**Errata to
Fundamentals of Psychrometrics (I-P), Second Edition
(2016)**

December 4, 2017

Figure 3-2 Plotting intersection of dew-point temperature on the psychrometric chart.

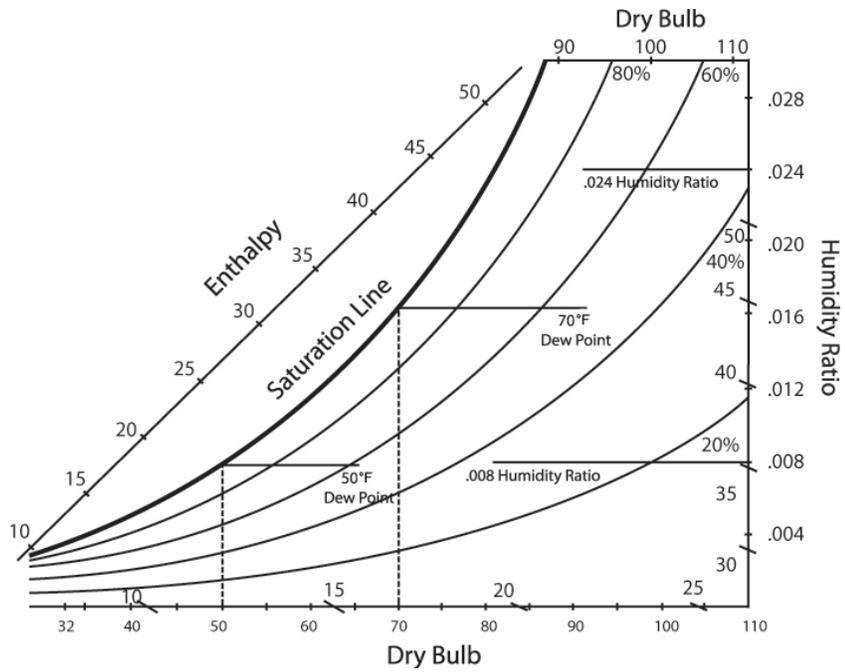
- Page 13:** Figure 3-2 erroneously showed dew-point values as percentages instead of temperatures. Please replace Figure 3-2 with the corrected figure included at the end of this errata sheet.

Figure 3-5 Climatic design information plotted on the psychrometric chart (detail).

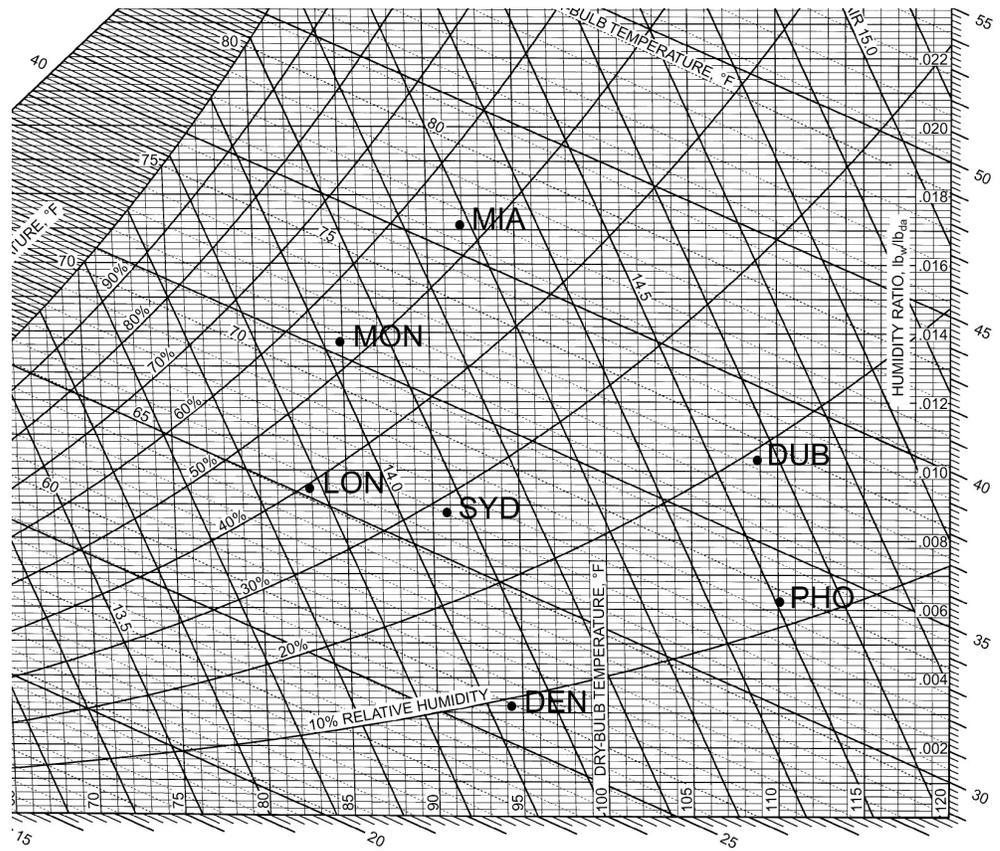
- Dubai, United Arab Emirates
 - London, Heathrow, UK
- Page 17:** A version of Figure 3-5 was published that includes cities no longer included in the Climatic Design Information in Appendix C. Please replace Figure 3-5 with the corrected figure included at the end of this errata sheet.
